Moorebank Intermodal Precinct East - Stage 2 & Concept Plan Modifications

*State Significant
Development and Part
3A Modification
Assessment*

*(SSD 7628 MOD 2 &
MP 10_0193 MOD 3)*

January 2020

Figure 3 | Revised OSD 2 design and site boundary (Source: Modification Report, Costin Roe)

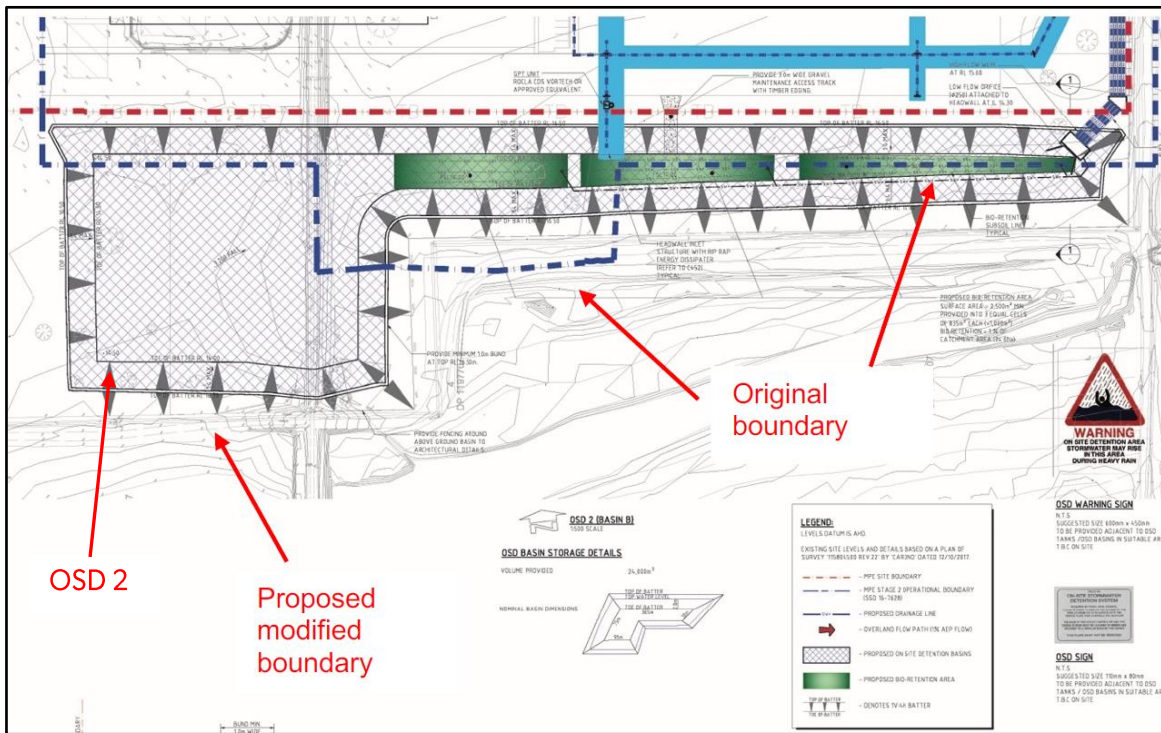
- the Applicant should review the boundary of the proposed works for OSD 2 and confirm no works are undertaken within the riparian corridor of Anzac Creek
- the proposed modification to stormwater detention basin 9 was justified
- there is a need to have high quality, carefully selected landscaping along the boundary of OSD 9
- the Applicant should address potential health issues if there's stagnant water in OSD 9.

Issue	Findings	Recommended Condition
OSD 2	<p>boundary footprint.</p> <ul style="list-style-type: none"> The Department also sought additional justification for locating OSD 2 outside the existing site footprint and alternative layouts which avoid threatened plants or reduce the area/number of threatened plants impacted. The Applicant in their RtS stated that the development of OSD 2 is constrained due to the: <ul style="list-style-type: none"> maintenance of the warehouse Gross Floor Area threshold presence of additional threatened species to the west shape of the Butcher's Knife lot adjacent to the Boot Land footprint of the proposed realignment of Moorebank Avenue 3 m wide maintenance access to satisfy condition B40(c)(v) 	<p>necessary.</p>
Safety and Access	<ul style="list-style-type: none"> The Applicant outlines safety measures that apply to OSD 9, considering it was built with vertical walls, including perimeter fencing, hazard signage, access ramps, flood depth indicators and refuge areas. 	<ul style="list-style-type: none"> No additional conditions or amendments necessary.

Figure 5 | OSD 9 layout, proposed (left) and original (right) (Source: Applicant's Modification Report)

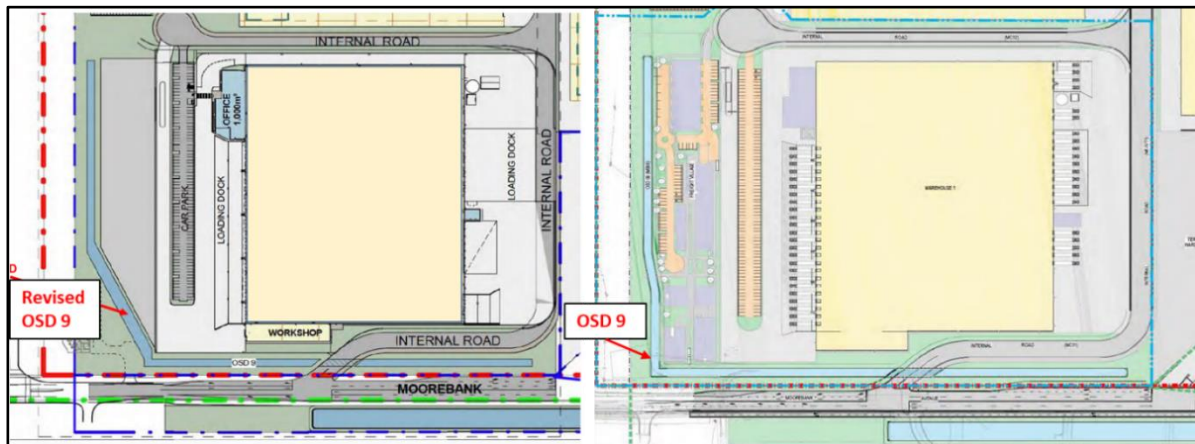
The Applicant proposes to delete the design criteria requirements in relation to OSD 9, to remove the requirement for 1V:4H batter slopes under condition B40(c)(iii). The design amendment will not relate to other OSD basins on the MPE site.

The modification application states that the proposed removal of the requirement for 1V:4H batters for OSD 9 does not have any implication for the functionality of OSD 9, nor does it seek to change the obligations to demonstrate this functionality in accordance with all aspects of condition B40. The Applicant advised that spatial restrictions on the OSD 9 footprint necessitated the construction of OSD 9 as an open basin with vertical walls, rather than 1V:4H batter slopes as required under condition B40(c)(iii) of the existing SSD 7628 consent.

OSD 9 as described in the modification application SSD 7628 Mod 2 must comply with the conditions of this consent, including Condition B40, except for Condition B40(c)(iii).

The Department considers the proposal is acceptable as it seeks to change one of the design parameters and will allow the Applicant to finalise a better drainage design. The Applicant must continue to comply with all other conditions of consent.

Figure 7 | Proposed extended construction and development footprint (Source: Revised BDAR, Arcadis)

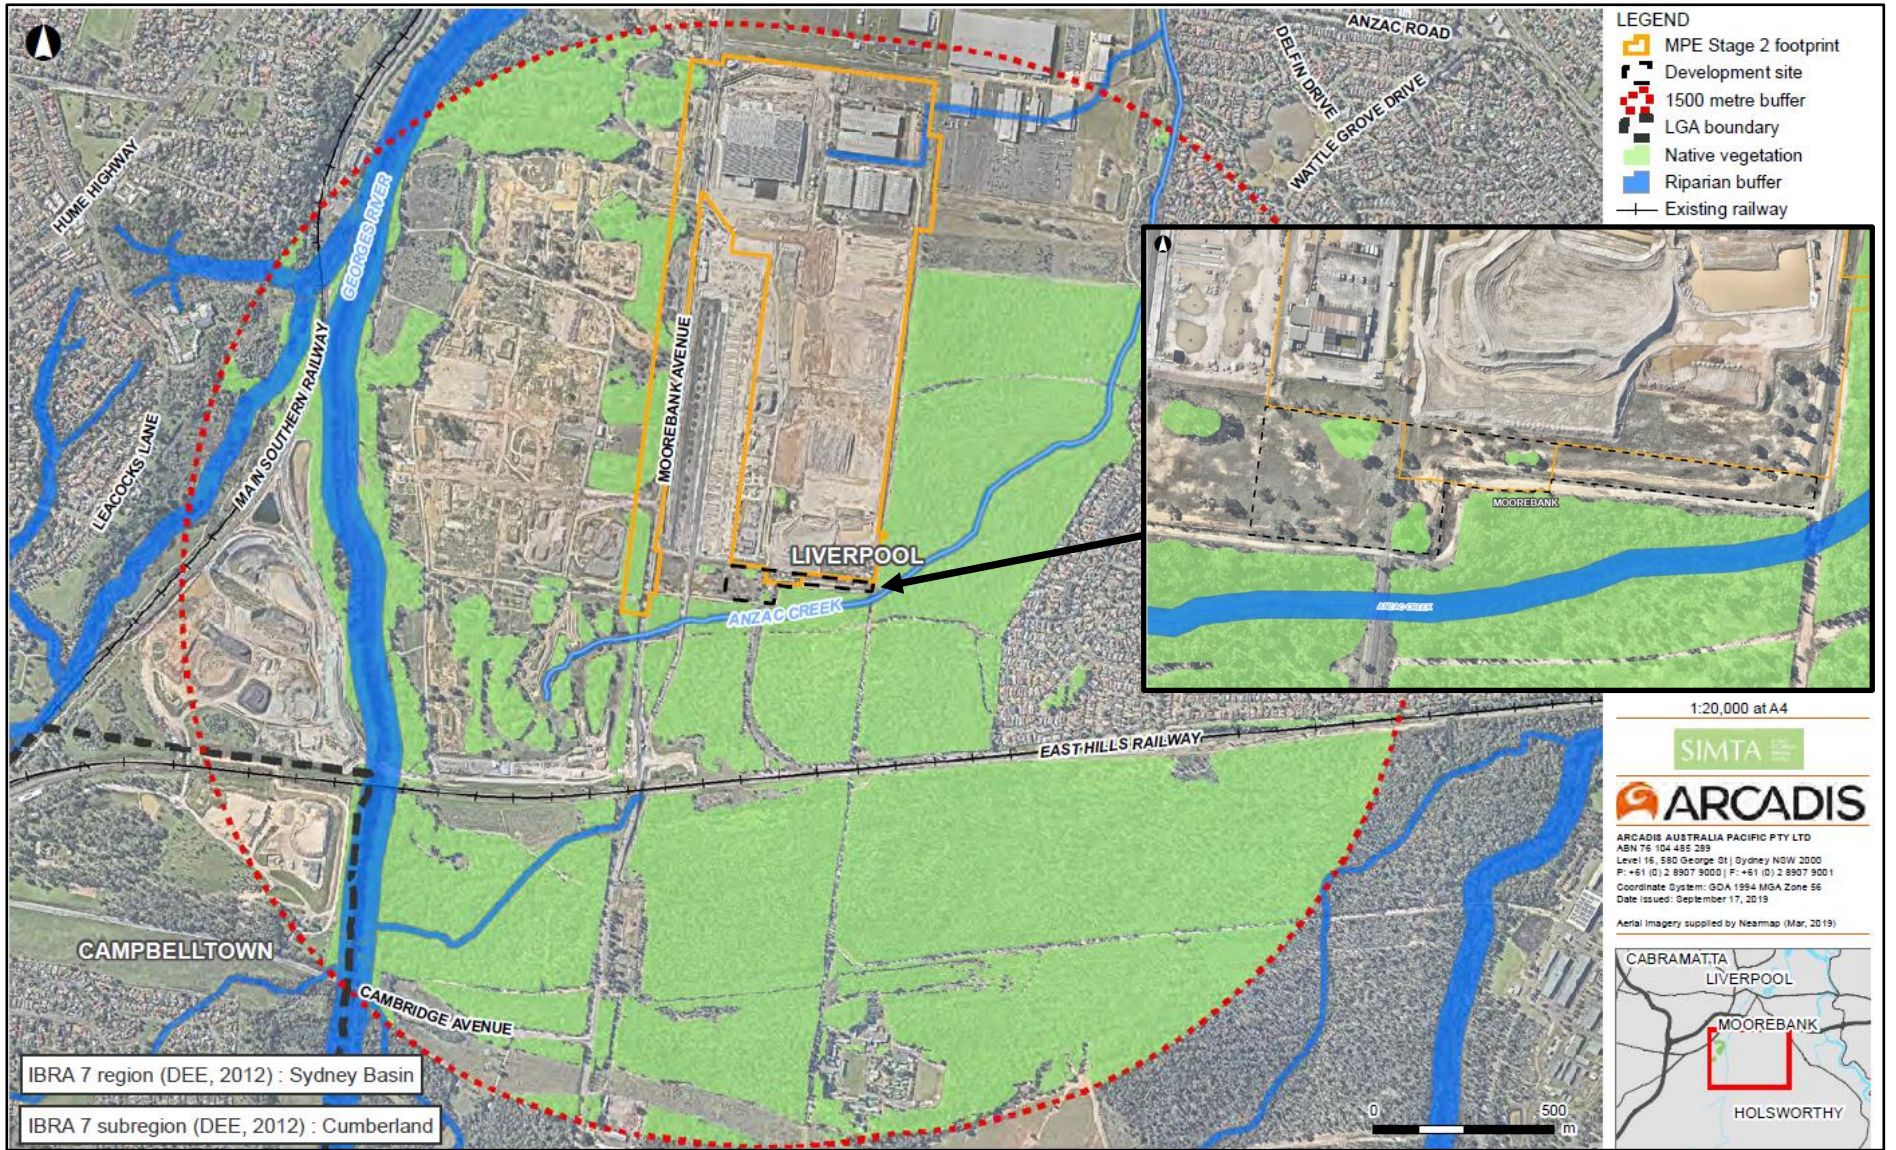
Council raised concern about the impacts to Anzac Creek as a result of the proposed footprint encroaching into the riparian zone of Anzac Creek. Anzac Creek is an ephemeral creek that originates within the MPW site from the cleared lands of the former golf course and flows north-east across Moorebank Avenue through the Boot Land (see **Figure 7** above).
